**TRANSIENTS / HARMONICS
STUDY REVIEW**

**SOUTHWESTERN
CONNECTICUT
RELIABILITY PROJECT**

FINAL REPORT

15 JUNE 2004

Drawing No.	Figure 2	Date:	11-06-04
Title			
BASED ON FINAL REPORT NOV 2003 EAST DEVON TO BESECK 40 MILE CABLE P1			
Report Number			
33.00/PP01:62049A

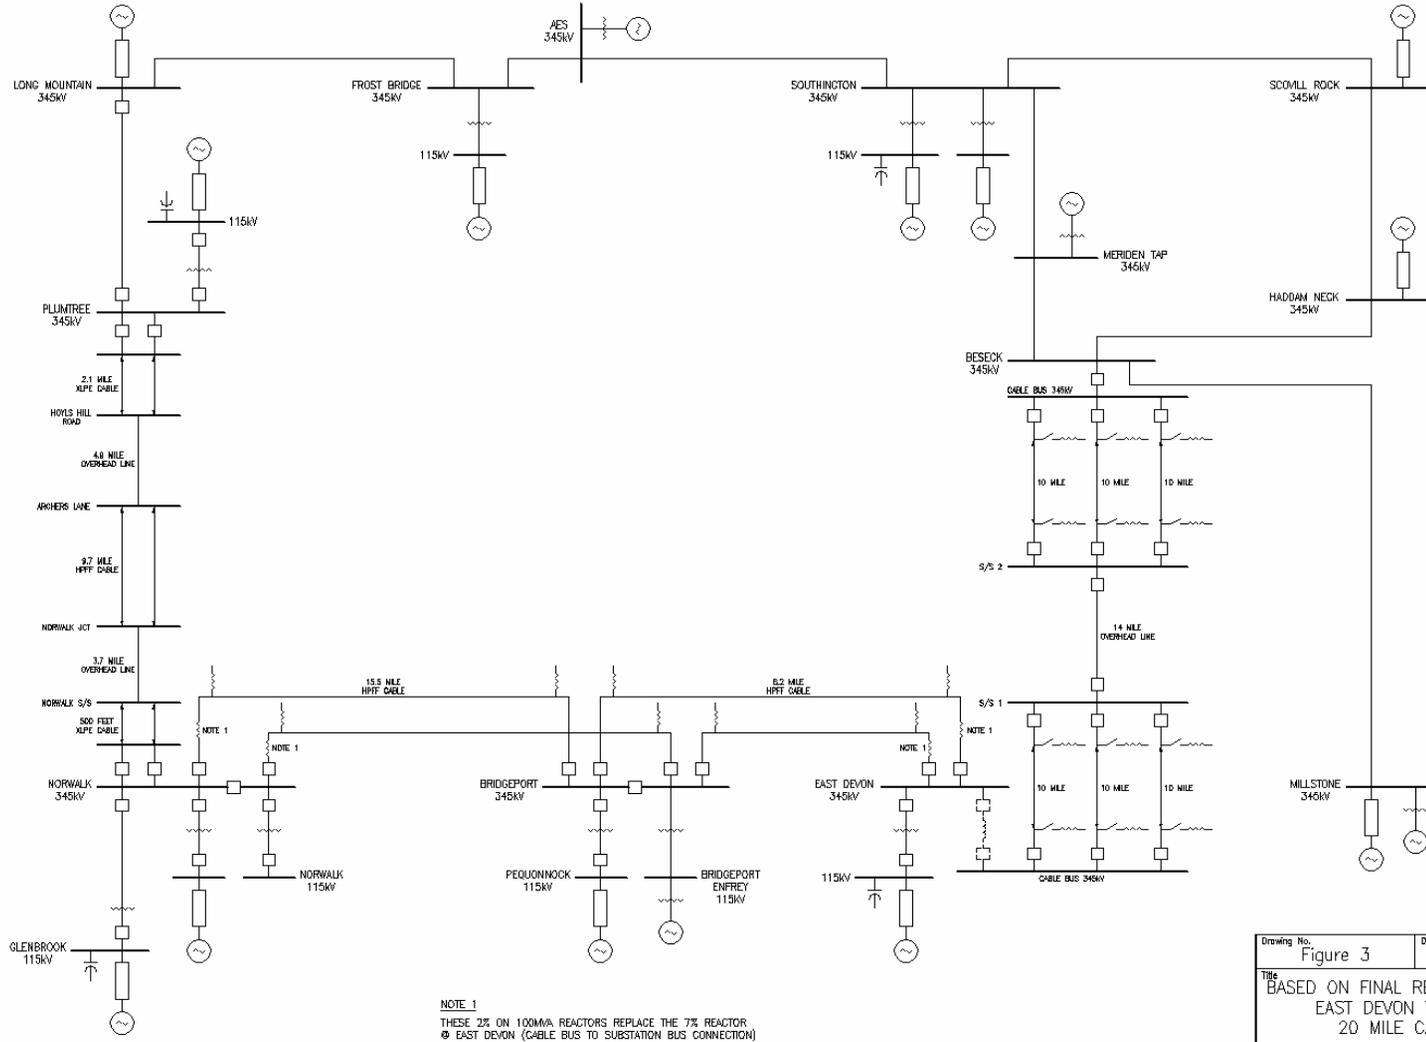
Figure 2 illustrates the worst-case scenario in terms of quantity of cable required.

The following principal observations may be made on the GE transmission cable model:

- XLPE insulated cable has been selected for short route lengths only and HPFF pipe-type cable has been selected for all other routes.
- Three parallel cable circuits are routed between Beseck and East Devon.
- The cable circuits between Beseck and East Devon are interrupted at 10 mile intervals in order to connect shunt reactors.

Selection of an alternative cable type to HPFF for the GE model would give benefits in terms of cable ratings and the level of MVAR's generated by the transmission network. However in the context of the application the firm rating would need to be considered, hence three HPFF circuits would provide a firm rating of 2 x 1000A and the best of the alternatives (XLPE) configured as two circuits would provide 1 x 1775A.

When considering the capacitance of the cables and hence the total MVAR generation it can be seen that only the XLPE cable offers any real advantage over the other technologies.

Drawing No.	Figure 4	Date:	11-06-04
Title	BASED ON FINAL REPORT APRIL 2005 OPTION ES-1A		
Report Number	33.00/PP01:62049A

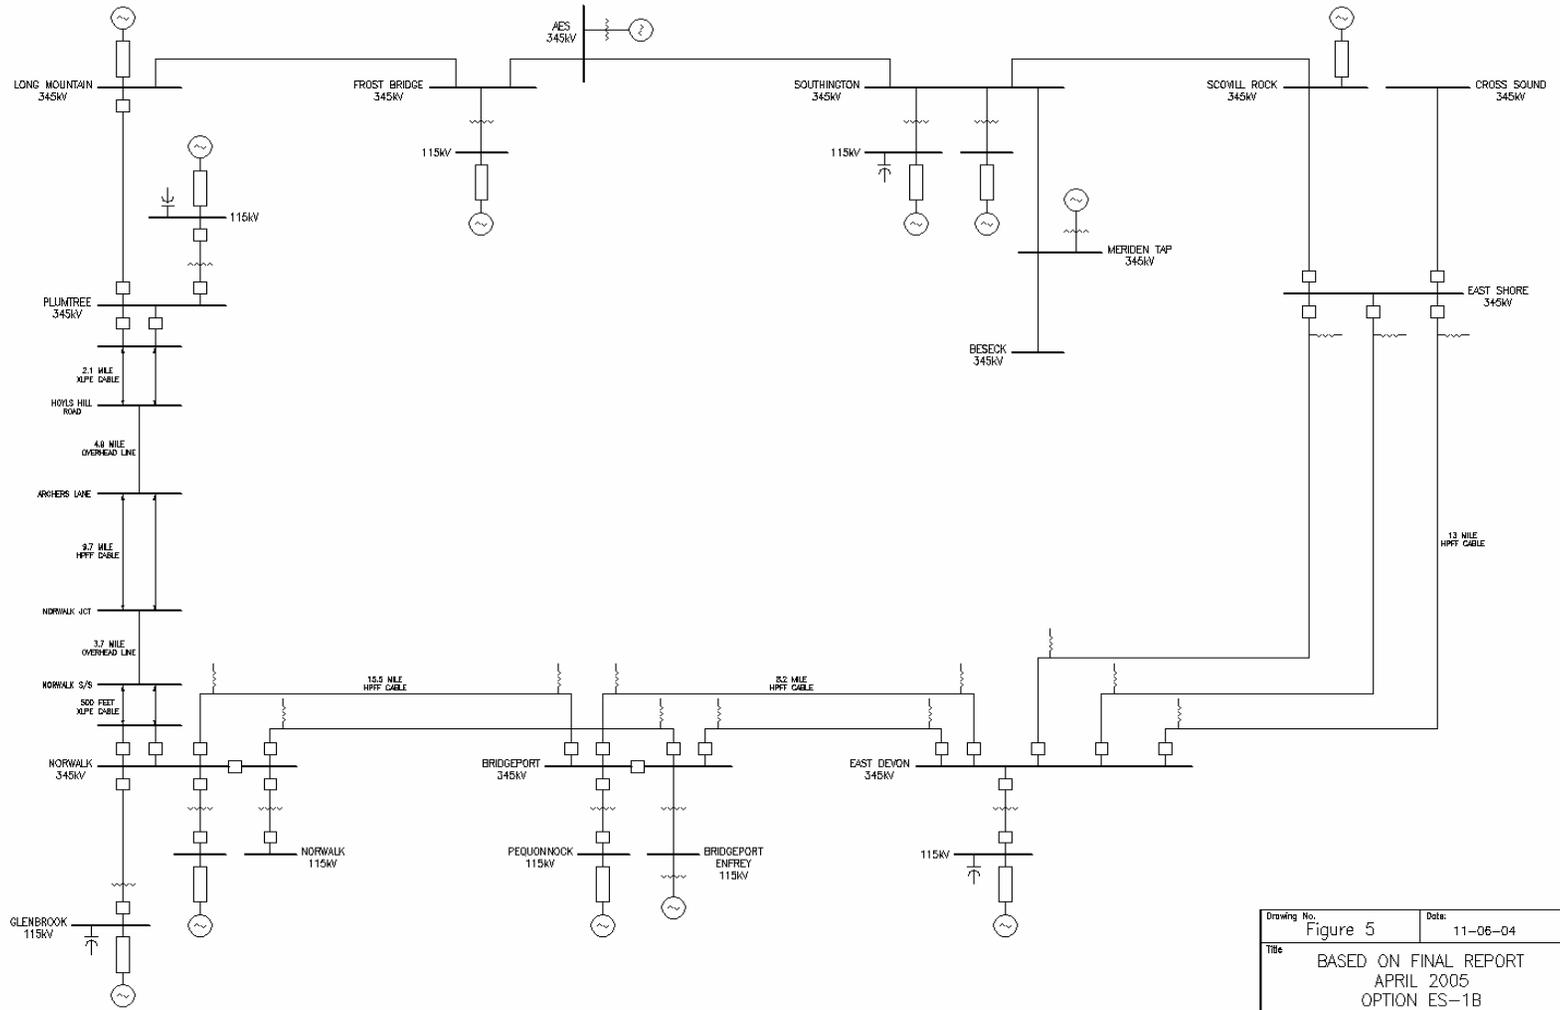
The level of complexity in certain of the options (Figure 4 – Figure 5), particularly for the East Devon – Beseck section, has increased considerably as compared to the proposed plan.

As an example, the proposal in East Devon – Beseck 40 Mile Cable Option (M/N-P1) introduces the following additional equipment as compared with the Phase 2 Final Report (November 2003) for the section between East Devon and Beseck.
